# E8358A-02F

# S E R V I C E N O T E

## E8358A PNA Series RF Network Analyzers

Serial Numbers: 00000000 thru 46999999

Figure 1

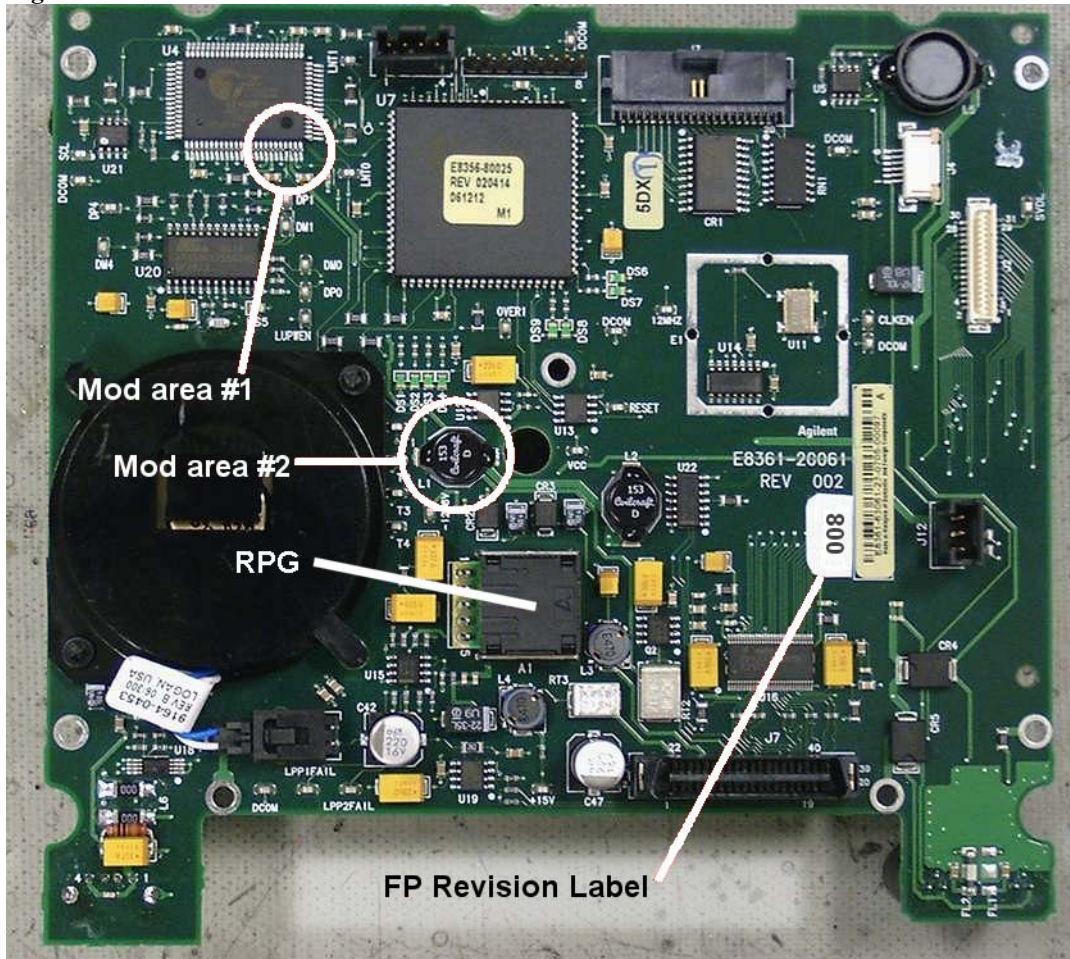
Refer to Figure 1 for the two modification areas to be addressed. Note that while this picture happens to show the FPI board completely removed from the front frame assembly, this is not necessary to perform the required modifications.

- Modification #1 consists of shorting two pins of U4 together with a small amount of solder.
- Modification #2 consist of removing L1.

Figure 2

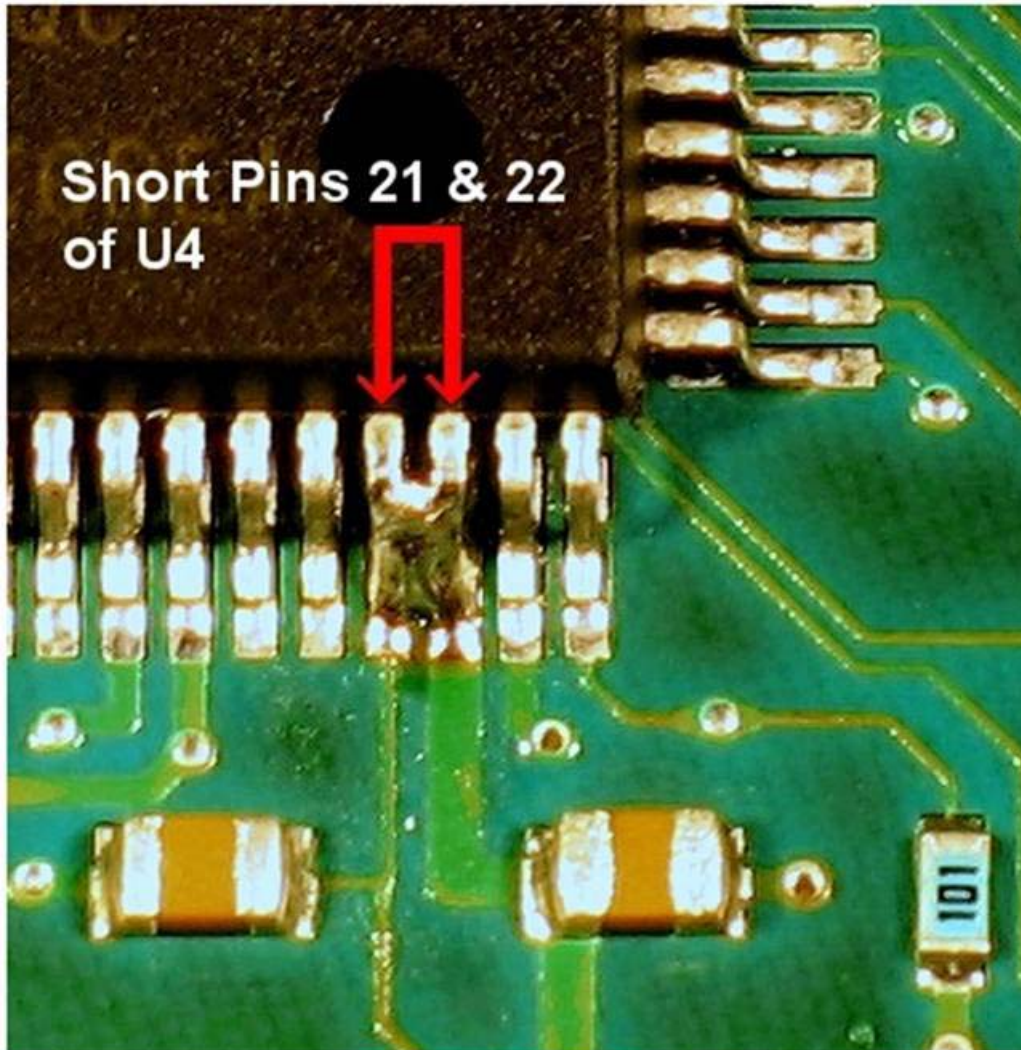
Carefully solder pins 21 and 22 together on U4. Refer to Figure 2 for the exact location. Use care so that no other pins are shorted. Use of a very fine tip soldering iron is recommended and a large work-task magnifying glass is very helpful.
